REPORT: **DEVELOPMENT APPLICATION No. X/1436/2021 for a additions and alteration to existing residential care facility including landscaping, retaining, basement car parking and new substation at Ritz Nursing Home, 203-223 Leura Mall, LEURA NSW 2780**

RECOMMENDATION	That the Development Application X/1436/2021 for additions and alteration to existing residential care facility including landscaping, retaining, basement car parking and new substation on Ritz Nursing Home, 203-223 Leura Mall, LEURA NSW 2780 be refused.
-----------------------	----------------------------------------------------------------------------------------------------------------------------------------------------------------------------------------------------------------------------------------------------------------

PART 3 **Report of Council's Conservation Architect / Heritage Advisor**

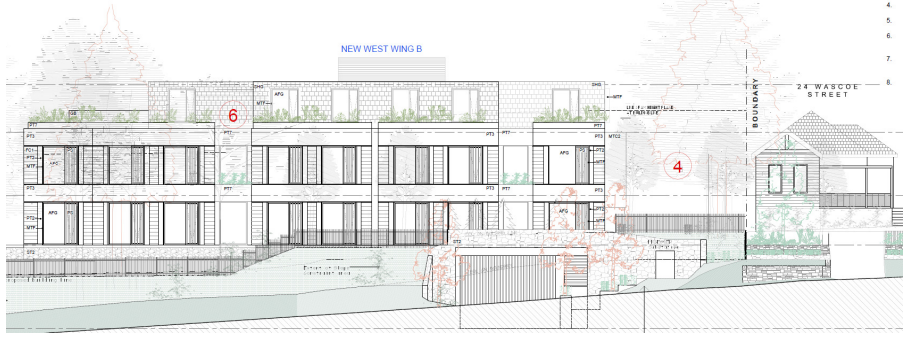
Test 2 – Sufficient environmental planning grounds	
Justification by applicant	<p>The submitted variation request relies on the following arguments (in summary):</p> <ul style="list-style-type: none"> • The viability of the project depends on the breach of the development standard. • The breach of the development standard allows for the retention, refurbishment and adaptive reuse of the heritage buildings. • Demand exists for the proposed use and the use requires a greater amount of floor space. • The exceedance does not impact on the amenity of adjoining properties. • The additional floorspace does not impact on existing views to and from the site, nor the site's landscape values. <p>Refer to submitted 4.6 variation request for detail.</p>
Assessment	<p>The viability of the project is not considered to be a relevant consideration in assessing the proposed variation to the FSR development standard.</p> <p>Documentation supporting the proposed development, including the submitted variation requests, refer to the 'retention', 'reuse' and 'refurbishment' of the existing heritage buildings. The retention and refurbishment of the heritage buildings is put forward as a key benefit of the proposal. However, retention, reuse and refurbishment are not considered to be accurate descriptions of the proposed works on the heritage buildings. Demolition Plan 01 and Demolition Plan 02 show that the 1892 building is being significantly altered through demolition of internal walls and that the structural walls and floors of the 1913 wings are being demolished with only the facades and roofs being retained. Rather than 'retaining' and 'refurbishing' the heritage buildings, the heritage buildings are being substantively demolished.</p> <p>Concern exists that the additional floorspace, in the form of an overly large West Wing, has a negative impact on the amenity of the dwelling at 24 Wascoe Street through reduced solar access.</p> <p>As noted elsewhere in this report, the FSR control applies to Leura Precinct R1-LE03. It does not apply only to this site and was not tailored to the context of this site. It is suggested that the 0.4:1 FSR control was put in place by the plan makers to assist achievement of the precinct objectives, including precinct objective (e), on otherwise unencumbered sites. On an unencumbered site, building mass could reasonably be expected to be evenly spread across the site, subject to other controls such as setbacks being respected. Therefore, in the context of an unencumbered site, bulk and scale would be minimised and would likely be consistent or compatible with the bulk and scale of existing cottages, as envisaged by precinct objective (e). The necessary 'sterilisation' of a large portion of the site which is taken up by the historic buildings, and the high-value landscaped areas in the north of the site, indicates that the maximum FSR control is unlikely to be achieved (let alone a breached) on this site. The concentration of a non-compliant amount of floorspace on the portion of the site less encumbered by heritage values necessarily means that the resulting building mass is not consistent or compatible with the bulk and scale of existing cottages, as required by precinct objective (e).</p>
